# HISTORIC AND DESIGN REVIEW COMMISSION

September 18, 2024

**HDRC CASE NO:** 2024-304  
**ADDRESS:** 2102 BROADWAY  
**LEGAL DESCRIPTION:** NCB 1763 BLK 33 LOT 1-4, 7-12, P-100-103 & P-105 -106 (PORTION OF CLOSED ALLEY)1  
**ZONING:** IDZ-3, RIO-1  
**CITY COUNCIL DIST.:** 2  
**APPLICANT:** Amanda Perez/PDI  
**OWNER:** 4M BROADWAY LLC  
**TYPE OF WORK:** Construction of commercial structures  
**APPLICATION RECEIVED:** August 20, 2024  
**60-DAY REVIEW:** October 19, 2024  
**CASE MANAGER:** Edward Hall

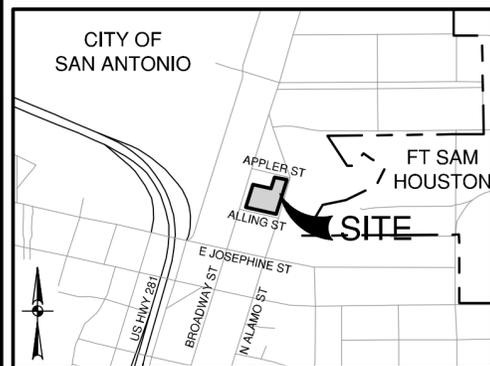
- Drawings updated with dimensioned elevations. There are no instances of an unbroken façade along ROW facing elevations.
3. That a detailed landscaping plan should be developed and submitted for review when returning to the Commission for final approval. ***This stipulation has been met.***
  4. That all mechanical equipment be screened from view with architectural building elements. This is to include roof level mechanical equipment. *Per the submitted elevations, there appears to be a significant amount of rooftop mechanical equipment that*

*will not be screened on top of both the restaurant building and pit house. Does the design team plan to address this? Screening of mechanical equipment is required by the UDC.*

- Elevations have been updated to indicate mechanical screening along ROW facing elevations. Intent is for mechanical screening to be constructed of expanded steel mesh to match stair enclosure material. Note: Elevation 1/A3.02 is not visible outside of the site.
5. That an inset of at least two to three inches within each wall is required. Additionally, staff recommends that if windows are to feature divided lites, that those divisions be true or applied on the exterior of glass and not be simulated on the interior of glass. *The construction documents note wood windows. Can you provide product specifications, a wall section and cut sheets for the windows?*

### Pedestrian Safety features at Parking Garage Entry

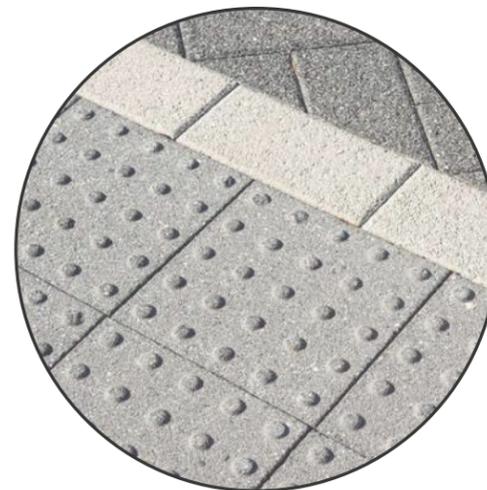
1. That the applicant incorporate the noted pedestrian safety features at the parking entrance, as well as install a landscaped pedestrian between vehicular lanes at the garage's entrance and exit. Additionally, one, uniform grade height across all curb cuts should be considered. *There was previous discussion regarding TxDOT not allowing our recommended mitigation. If that's the case, could you provide documentation of this? If the sub-grade garage is not included in the request at this specific time, we can note that.*

- Details regarding paving and truncated dome strips added to plans
- Convex mirrors and indicator lights located on garage entry elevations and plans
- Attached documentation regarding landscape pedestrian island attached.

- We are proposing a 10% speed ramp into the garage, and not maxing out the speed ramp (16%), thus creating better sight lines.
- Ability to shift the ramp further toward the east (into the garage) to create more flat driving surface prior to the sidewalk.
- Change in paving pattern
- "Truncated Domes" strip as pedestrian warning device
- Vehicle warning devices
  - Caution Car Coming" sign
  - Audible Alarms
- Convex Mirrors
